## PARTS & SERVICE NEWS

**REF NO.** | AA04179

**SUBJECT:** THE IMPROVED REAR AXLE DIFF. ASS'Y MOUNTING BOLTS AGAINST BREAKAGE

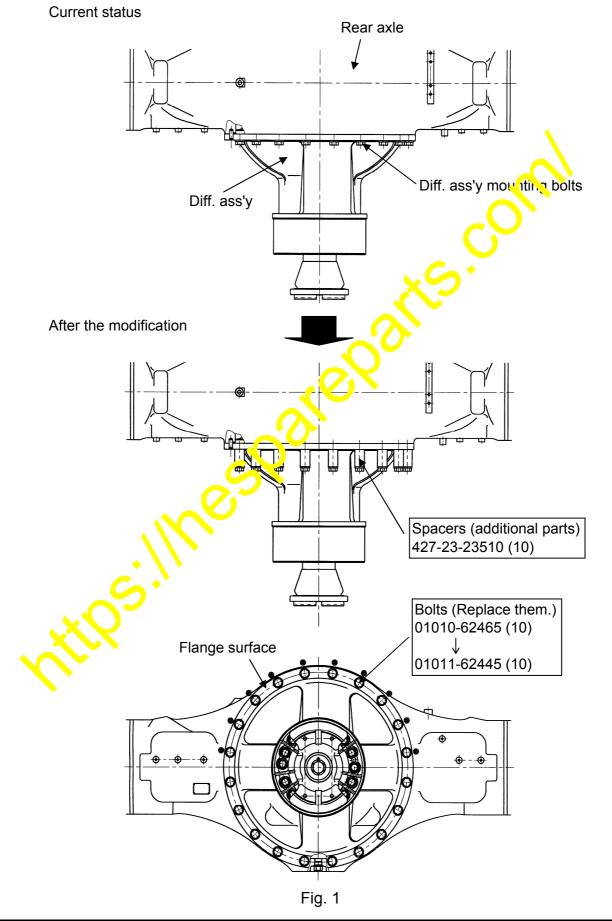
This Service News will introduce improvement of the mounting strength for the diff. carrier ass'y of the rear axle of WA800-3 and WA900-3.

By addition of a spacer at 10 sections on the upper side bolts (Marked  $\bullet$  in the drawing) among all the rear axle diff. ass'y mounting bolts, stress to the bolts can be decreased.

Part No.	Part Name	<mark>Q</mark> ty	Remarks
427-23-23510	Spacer	10	
01011-62445 (01010-62465)	Вол	10

AA04179 2. Installation procedure for the improved parts (1) Removal and reinstallation of the rear axle ass'y Refer to the Section "Removal and instillation of the rear axle ass'y" in the chapter "Disassembly and Assembly" in the Shop Manual. (2) Improvement work <1> Remove the bolts (01010-62465) and washers (01643-32480) located at the 10 places on the upper side (marked  $\bullet$  in the drawing). <2> Remove the paint completely from the contact surfaces of the spacers (427-23-23510) being used for the flange surface. <3> Install the spacer (427-23-23510) using the bolt (01011-62445) and the washer (01643-32460). Bolt: Apply LT-2. Bolt tightening torque: 824 - 1030 Nm {84 - 105 kgm} sillespare
